**Addendum No. 1**

Addendum No.1 form shall be part of the original ITB NO. 23-10 FRANJO ROAD ROADWAY IMPROVEMENTS PROJECT document and modifies the original ITB as noted below:

**Invitation to Bid (ITB) No. 23-10  
FRANJO ROAD ROADWAY IMPROVEMENTS PROJECT  
Town of Cutler Bay  
Florida Town Project ITB  
No. 23-10**

FRANJO ROAD

MIAMI-DADE COUNTY PUBLIC WORKS DEPT.  
 HIGHWAY DIVISION  
 FRANJO ROAD  
 FROM OLD CUTLER RD TO SW 184th STREET  
 PROJECT NO. 20190519 SHEET C-30 OF 82

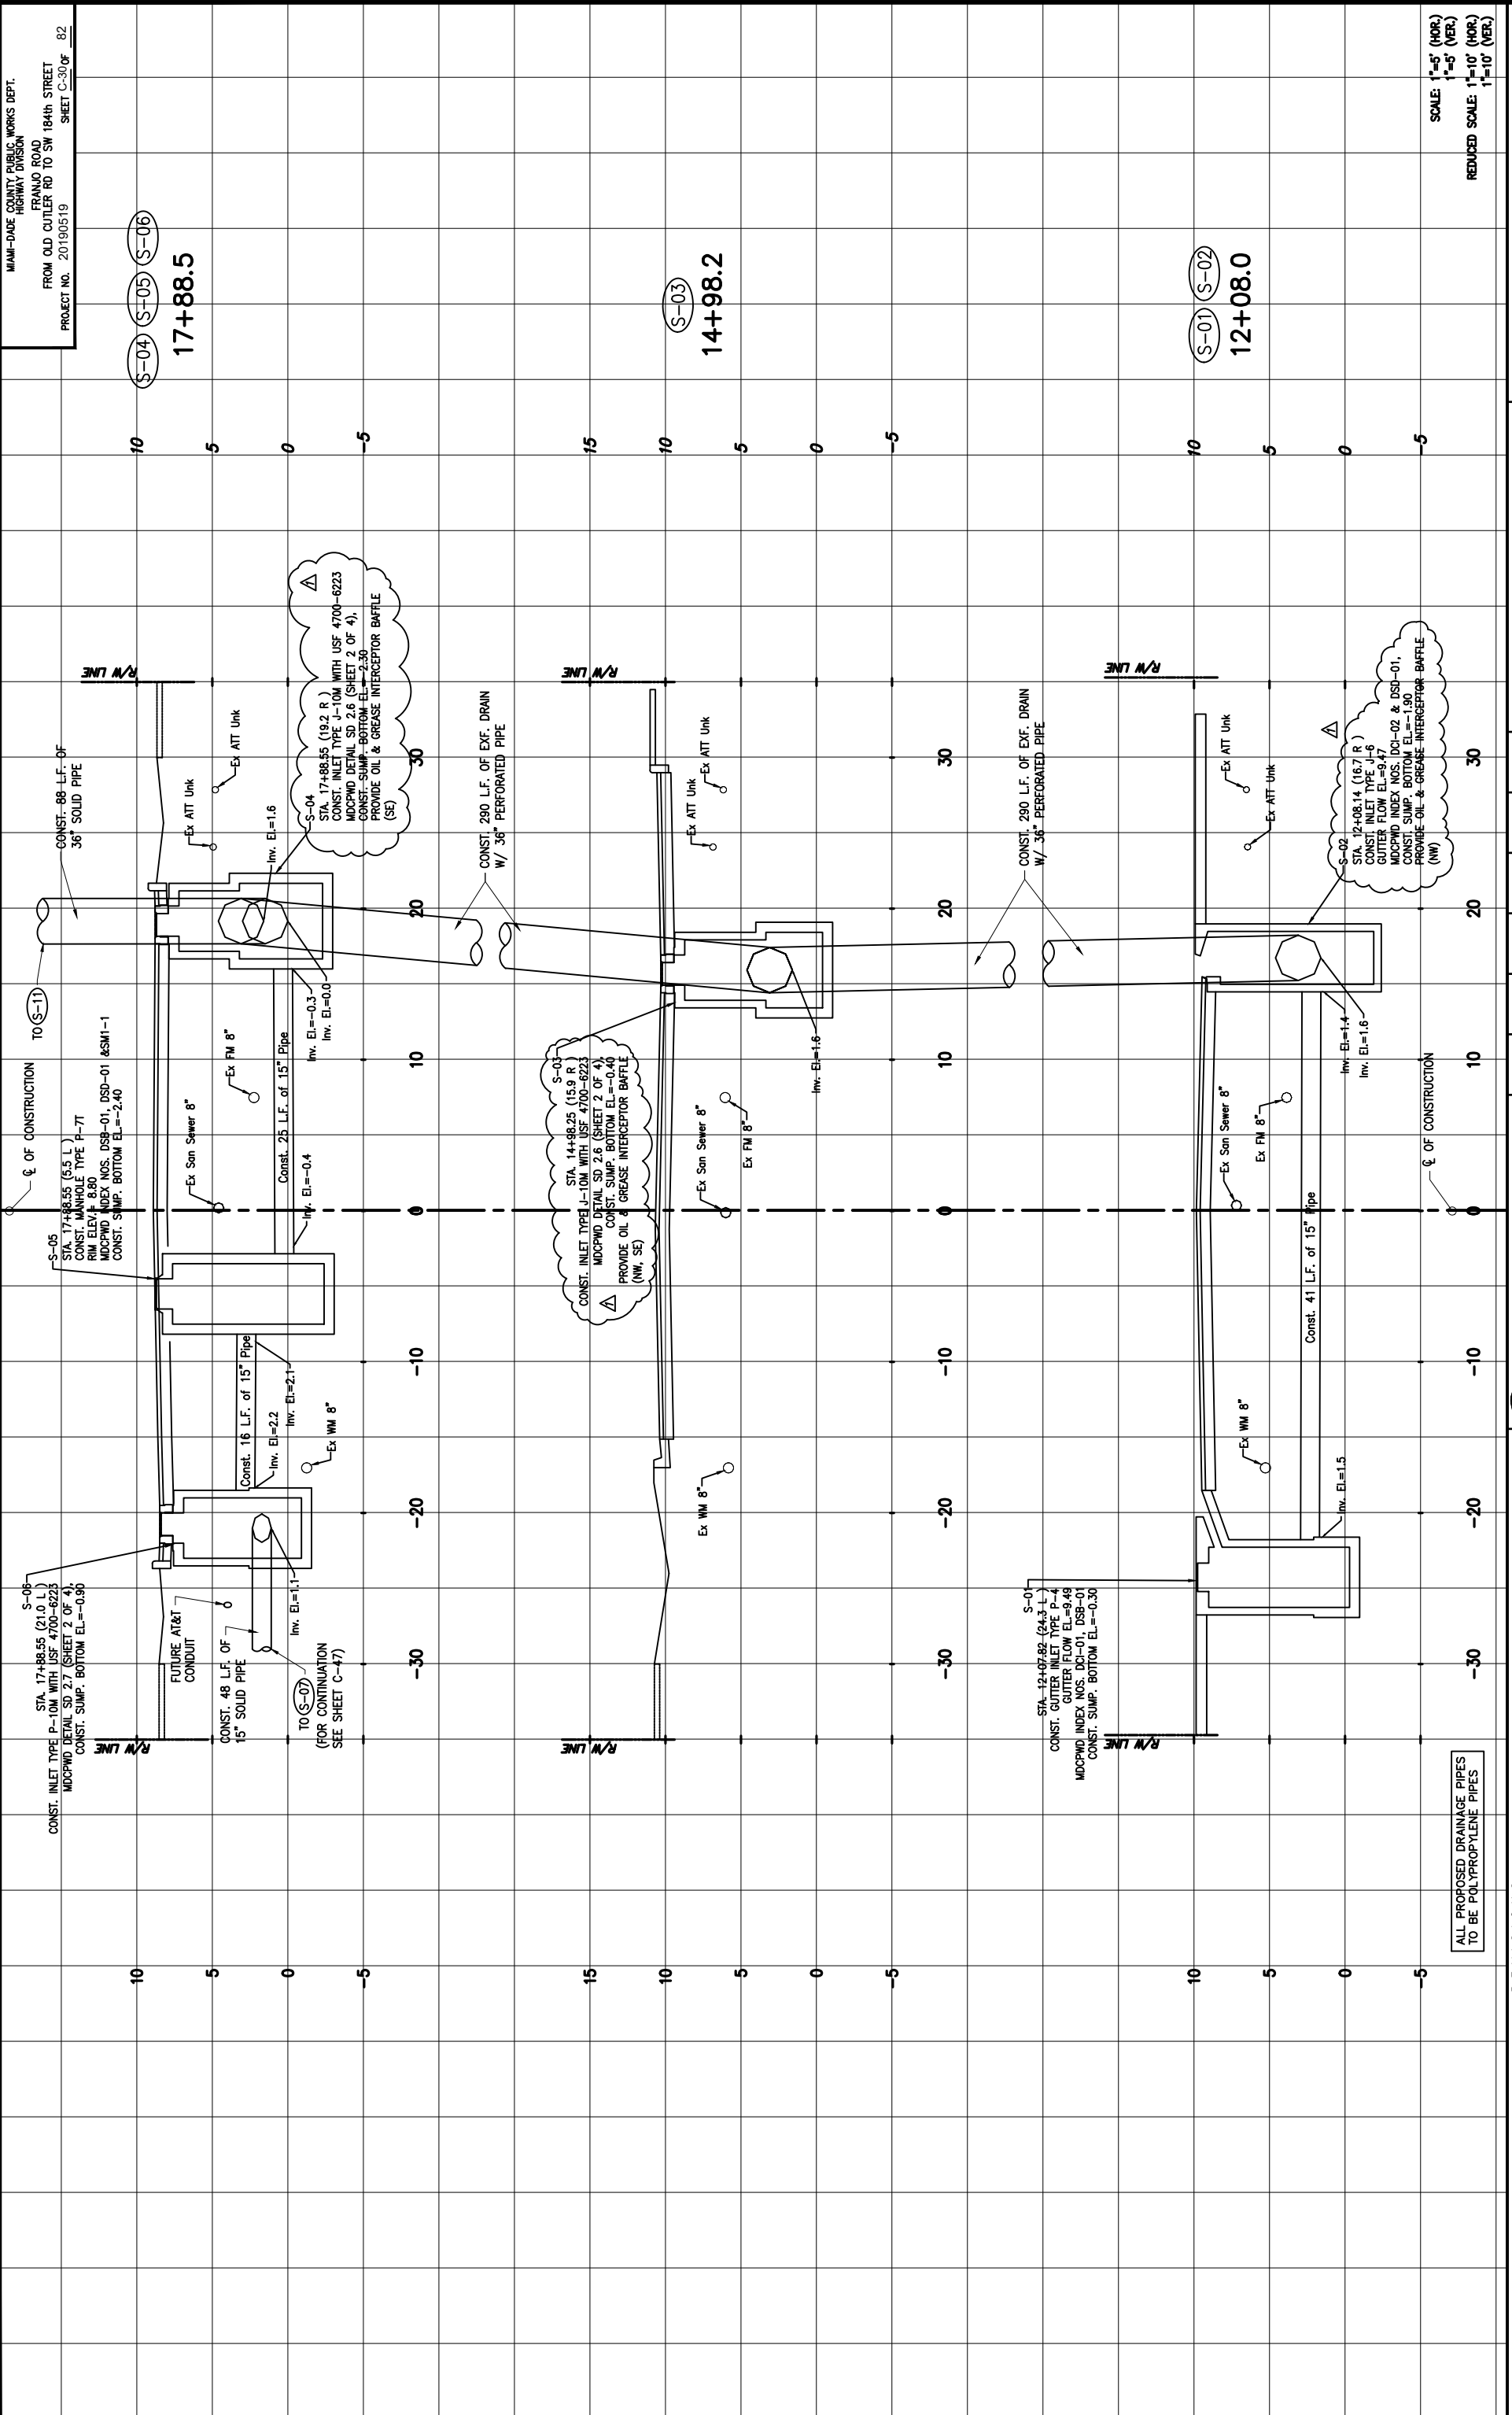
REVISION	DATE	DESCRIPTION
		ALL PROPOSED DRAINAGE PIPES TO BE POLYPROPYLENE PIPES

MIAMI-DADE COUNTY PUBLIC WORKS DEPT.  
 HIGHWAY DIVISION  
 FRANJO ROAD  
 FROM OLD OUTLER RD TO SW 184th STREET  
 PROJECT NO. 20190519  
 SHEET C-32 OF 82

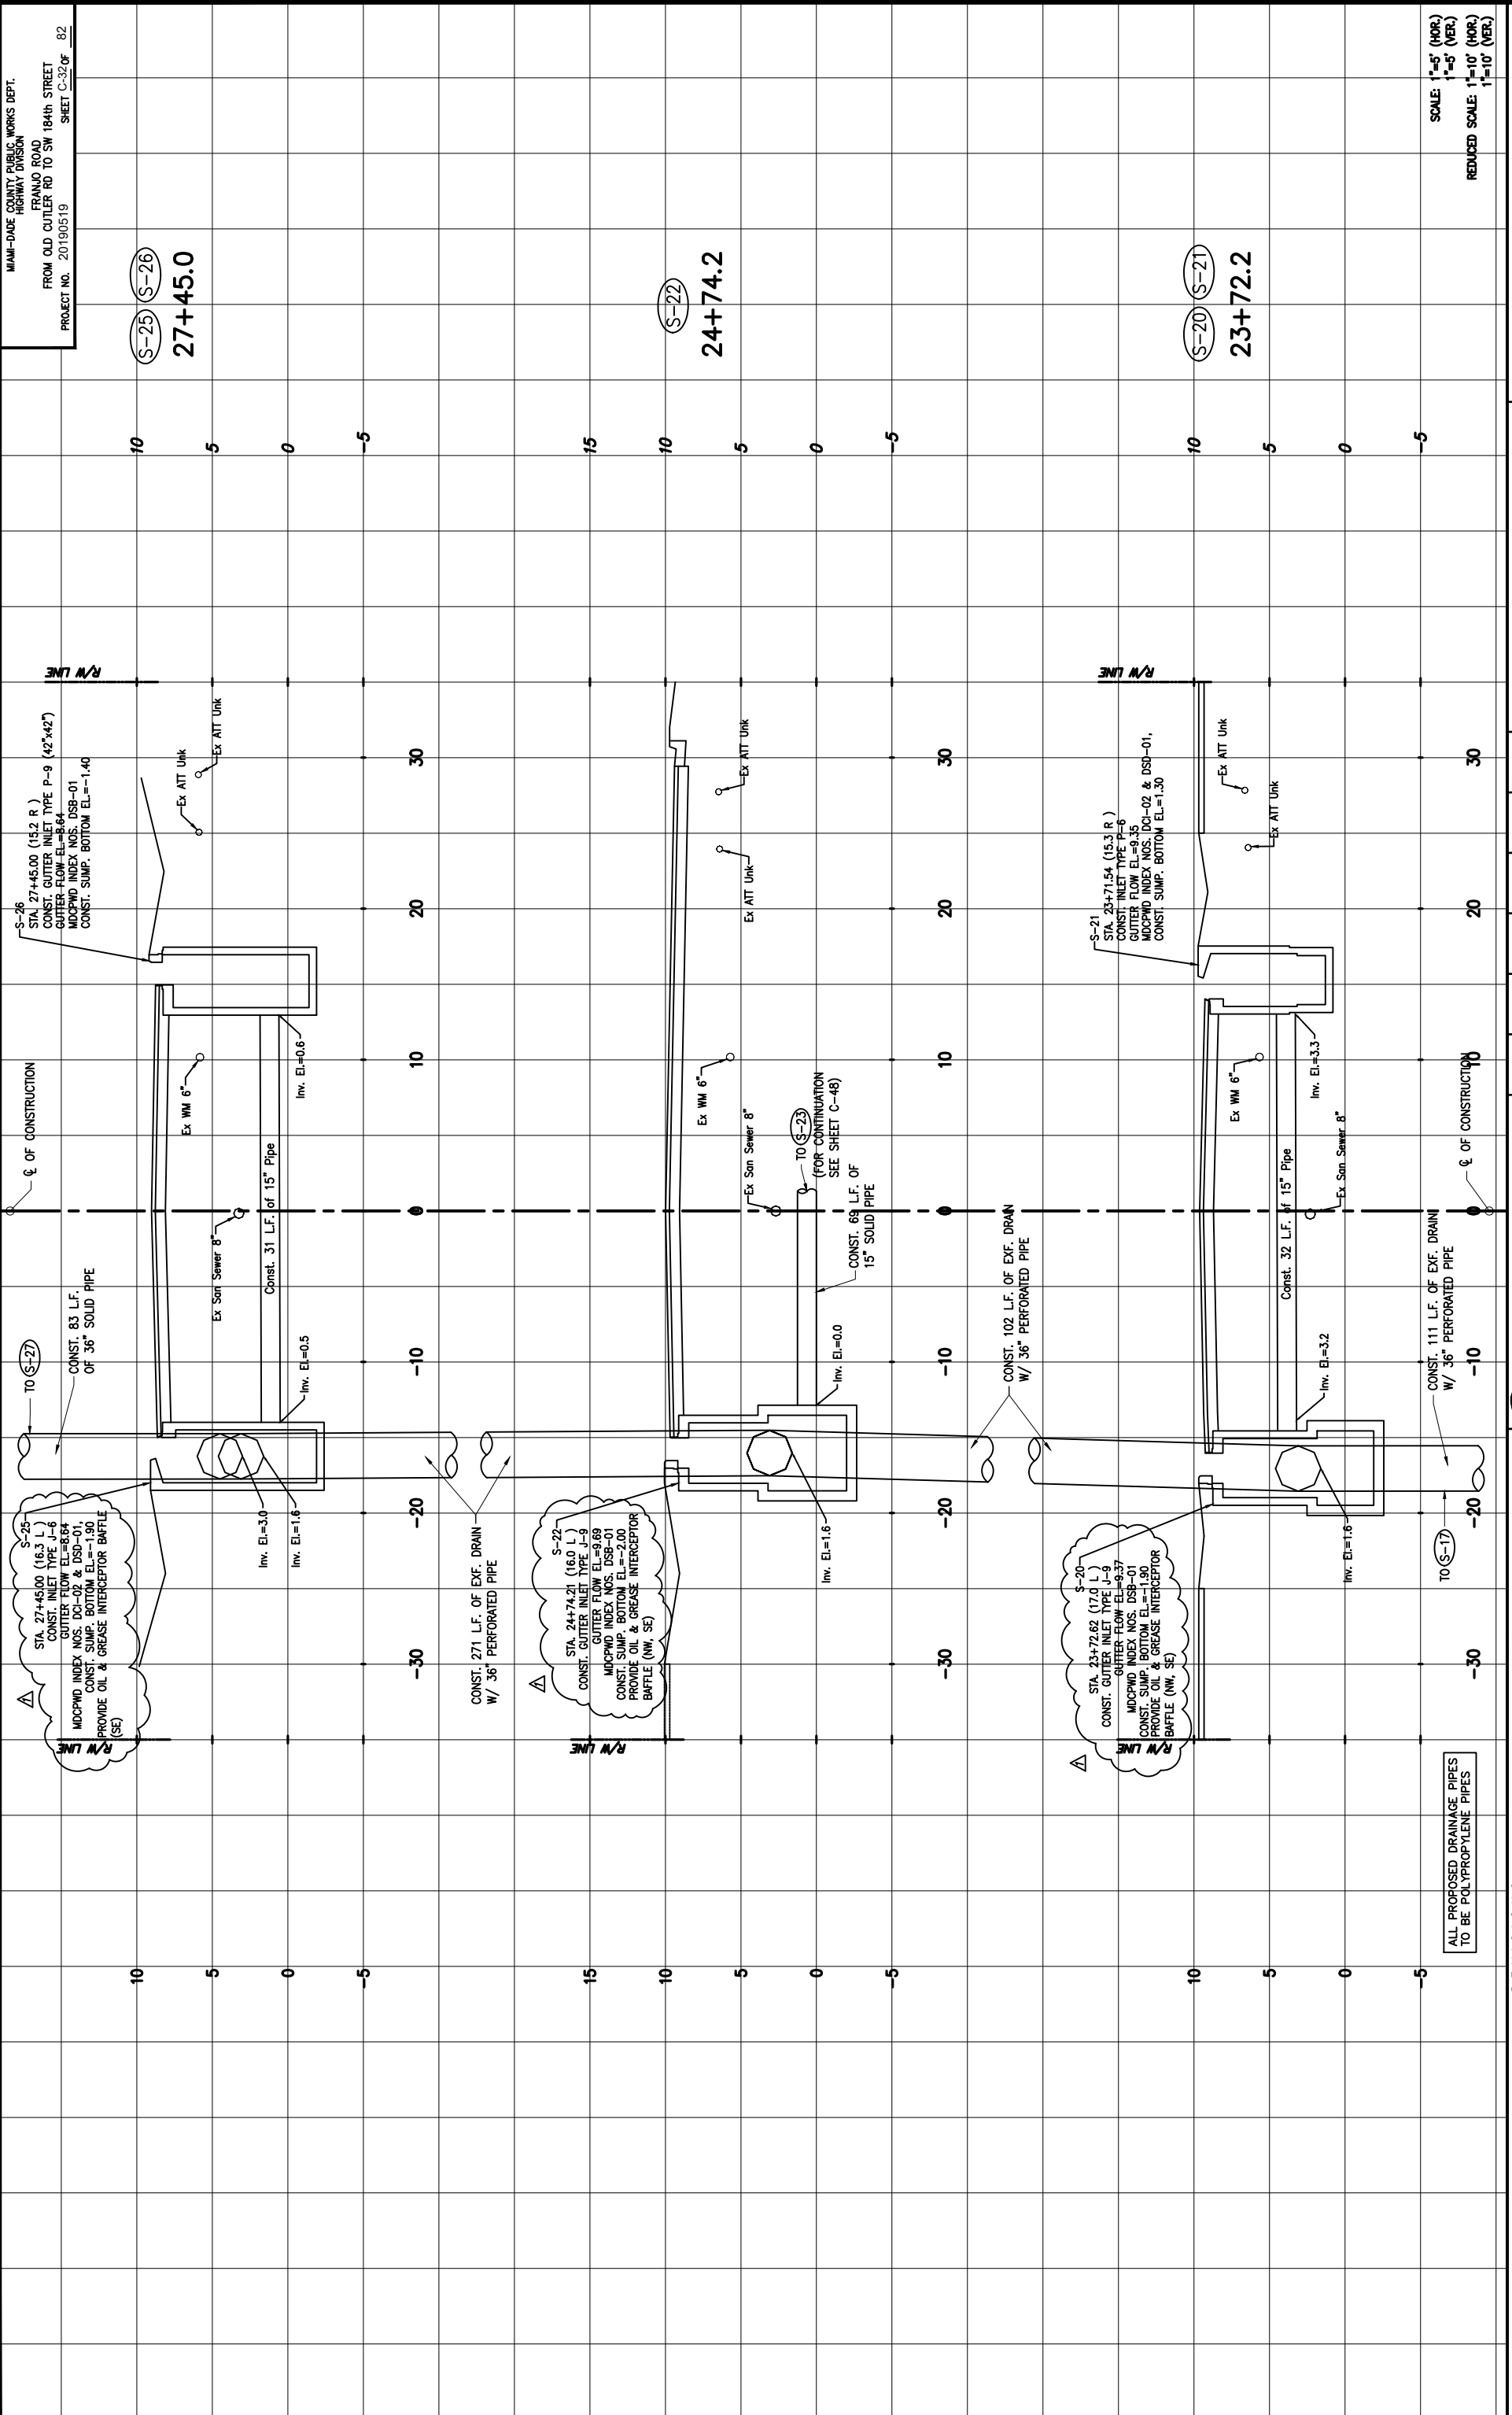
ALL PROPOSED DRAINAGE PIPES  
 TO BE POLYPROPYLENE PIPES

MIAMI-DADE COUNTY PUBLIC WORKS DEPT.  
 FRANJO ROAD  
 HIGHWAY DIVISION  
 FROM OLD OUTLER RD TO SW 184th STREET  
 PROJECT NO. 20190519  
 SHEET C-34 OF 82

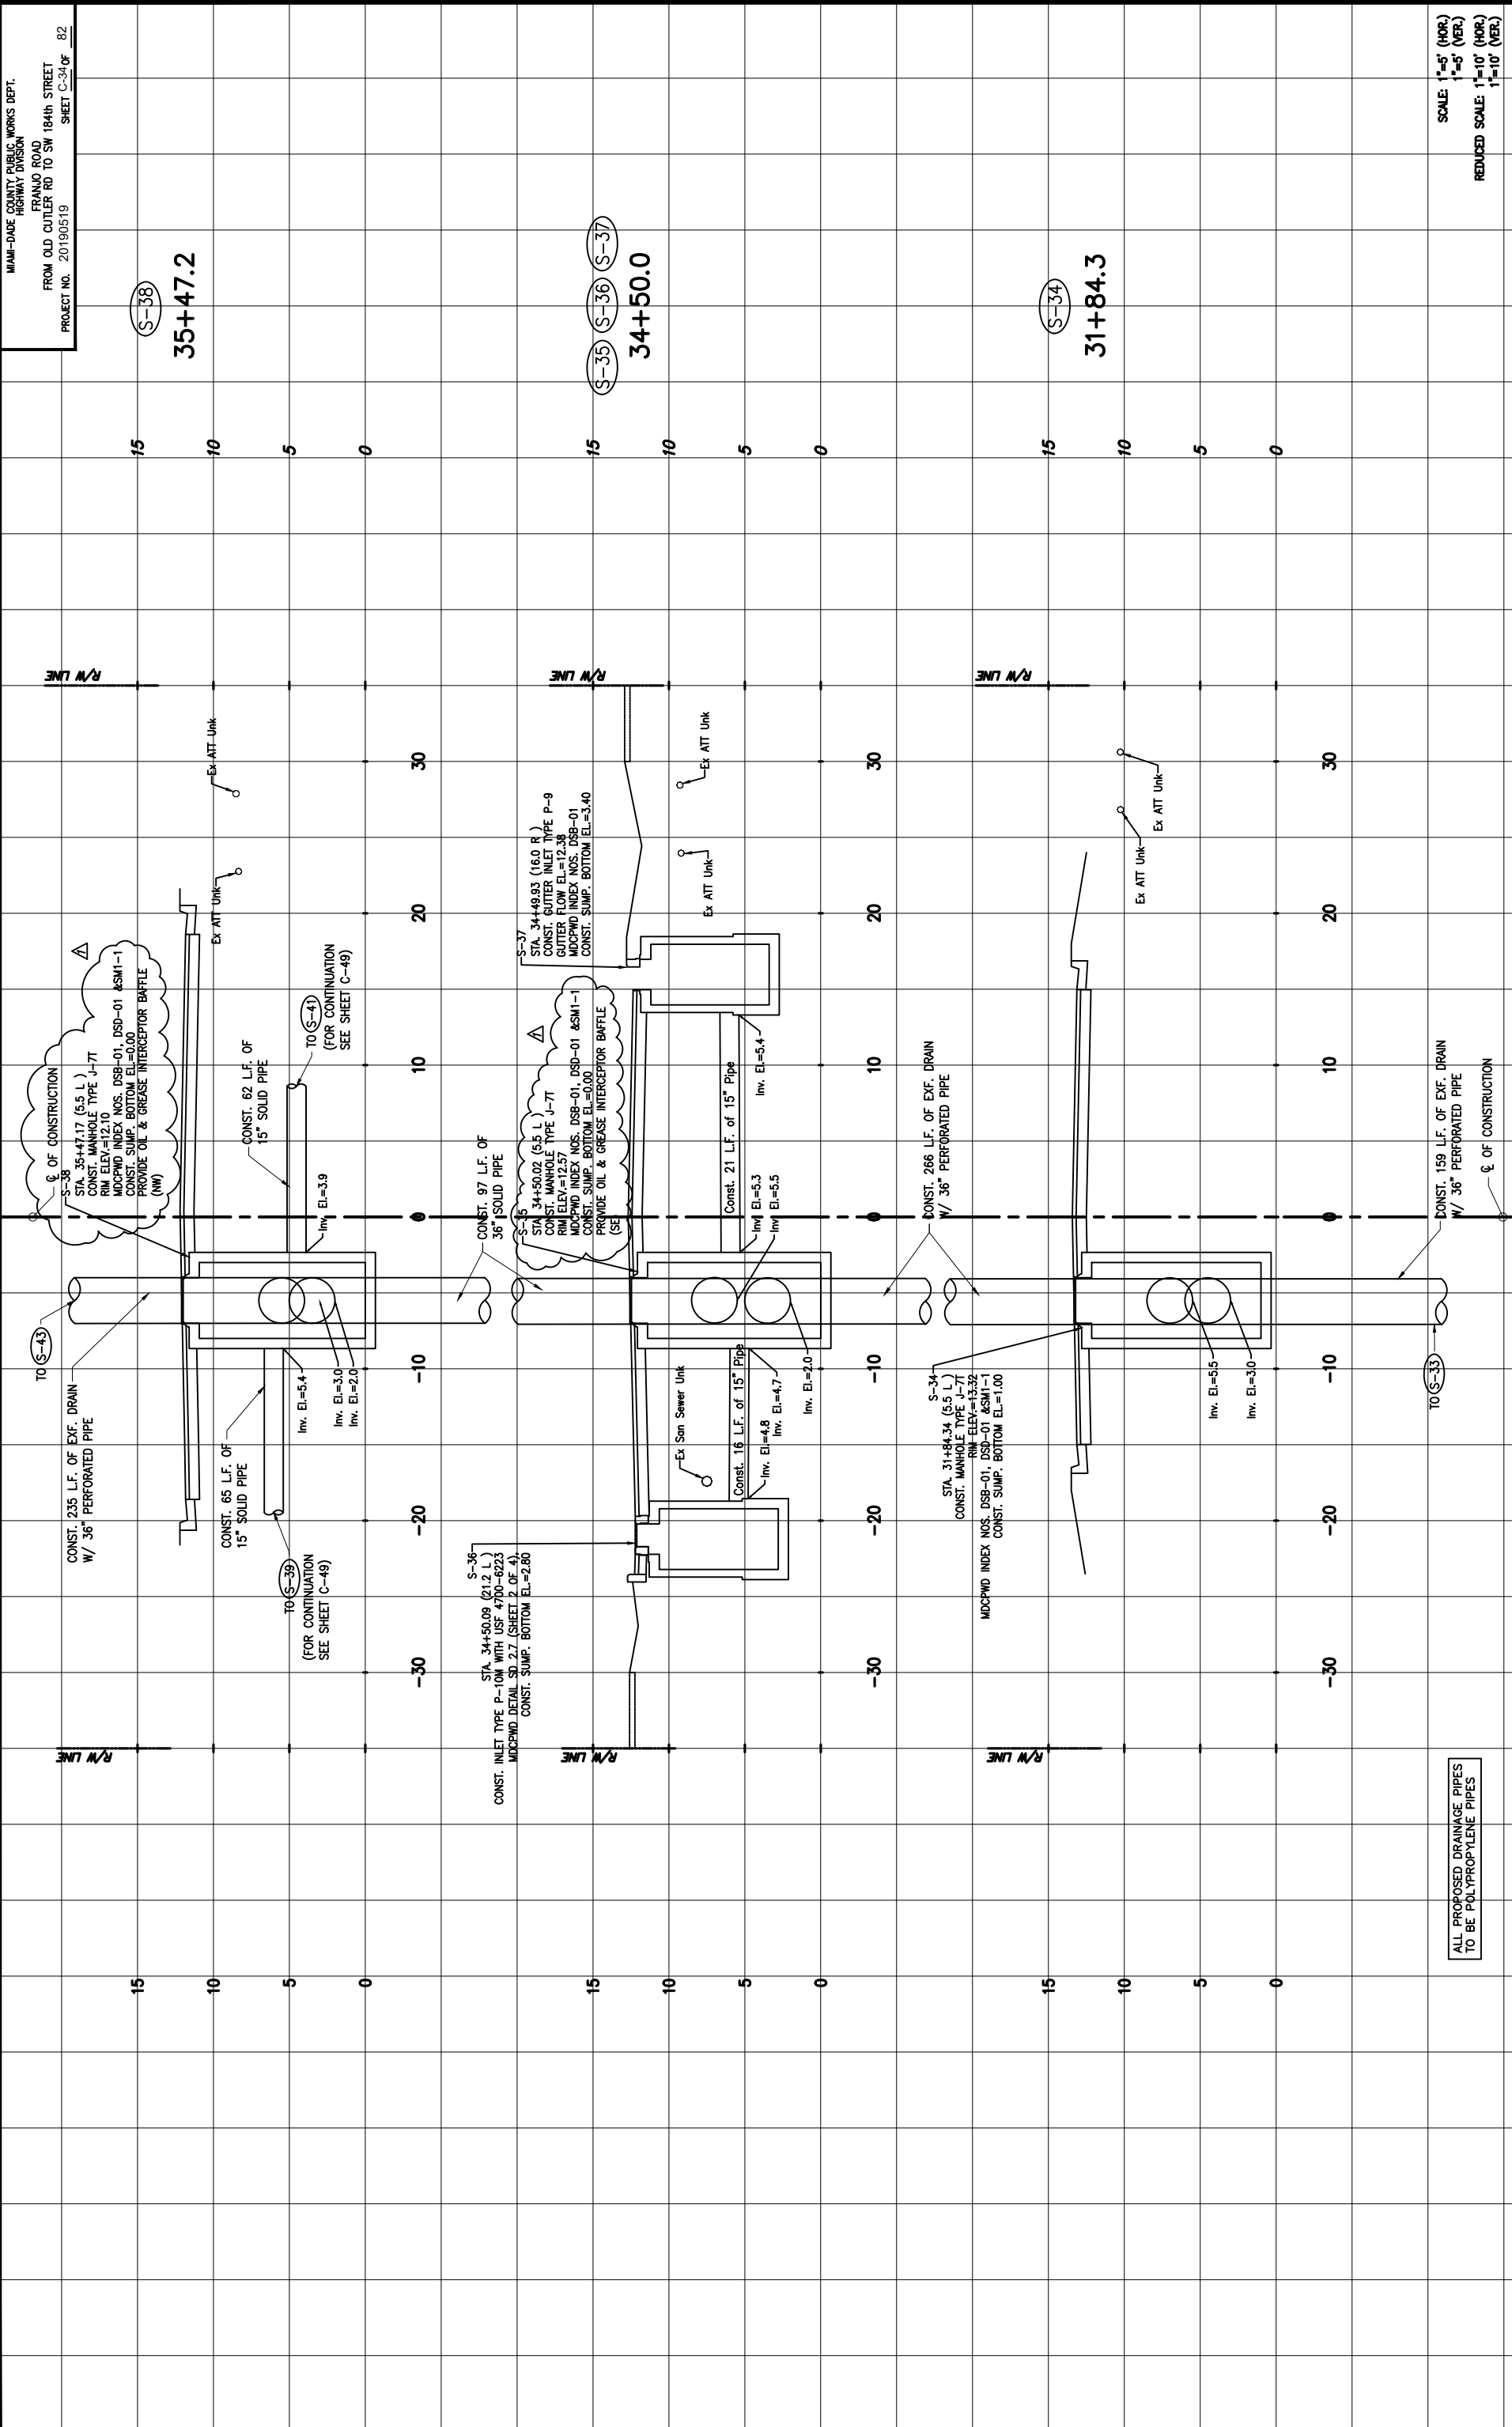
REVISION #	DATE	DESCRIPTION
1		ALL PROPOSED DRAINAGE PIPES TO BE POLYPROPYLENE PIPES
